Access Compliance Report

Public Rights-of-Way

Intersection ID: 48646	Main Street: SUMMIT_GREENWAY_CT	Cross Street: S SUMMIT_AV	Location: W
ADA ID: 102C9D2A6E75	Ramp Type: BlendTrans1	Initial Pass/Fail: Fail	Overall Compliance: No
		Severity Score: 10

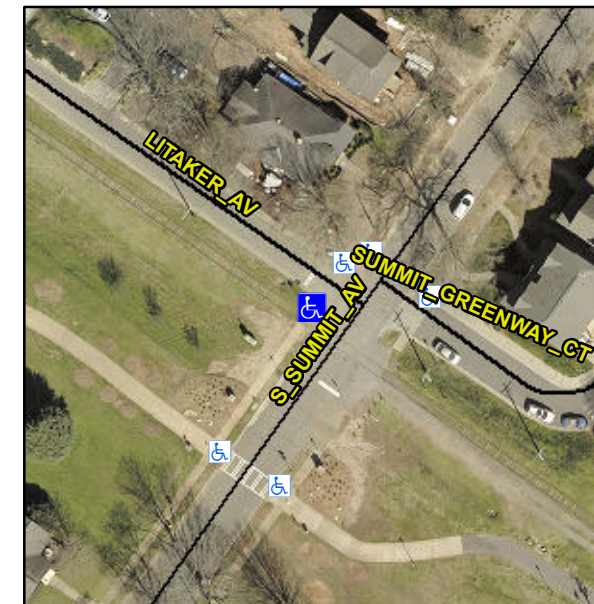
Not Found, R304.5.1, R304.5.3

Compliance	Description	Data	Compliance	Description	Data
N/A	Ramp Length (in)	62.0	Yes	BlendTrans Slope (%)	1.6
No	Ramp Width (in)	38.0	No	BlendTrans XSlope (%)	3.3
N/A	Flare Type LT	N/A	N/A	Flare Type RT	N/A
N/A	Flare Slope LT (%)	N/A	N/A	Flare Slope RT (%)	N/A
N/A	Flare Traversable LT?	N/A	N/A	Flare Traversable RT?	N/A
N/A	Landing Length (in)	N/A	N/A	DWS Provided?	N/A
N/A	Landing Width (in)	N/A	N/A	DWS Contrast?	N/A
N/A	Landing Slope (%)	N/A	N/A	DWS Length (in)	N/A
N/A	Landing X Slope (%)	N/A	N/A	DWS Full Width?	N/A
N/A	Landing Curb? (Y/N)	N/A	N/A	DWS Offset (in)	N/A
N/A	Shared Landing?	N/A			
N/A	Gutter Ponding?	N/A	N/A	Gutter Slope (%)	N/A
N/A	Gutter Lip Ht (in)	N/A	N/A	Gutter X Slope (%)	N/A
N/A	Painted X Walk1?	No	N/A	Painted X Walk2?	N/A
	X Walk 1 Direction	To N		X Walk 2 Direction	N/A
	X Walk 1 Width (in)	N/A		X Walk 2 Width (in)	N/A
	X Walk 1 Slope (%)	2.5		X Walk 2 Slope (%)	N/A
	X Walk 1 X Slope (%)	1.8		X Walk 2 X Slope (%)	N/A

N/A	Ramp inside XWalk1?	N/A	N/A	Ramp inside XWalk2?	N/A
	Road Slope (%)	1.8		Clear Space?	N/A
	Road X Slope (%)	2.5	N/A	Clear Space to XWalk (in)	N/A
N/A	Any Obstructions?	N/A	N/A	Storm Grate/Utility Hazard?	N/A
	Obstruction Type			Storm Grate/Utility Type	
		N/A			N/A
			Yes	Surface Condition? (G/P)	Good
			No	Curb Slope (%)	7.9

Remove & Replace Curb Ramp With Two New Directional Ramps or Equivalent.
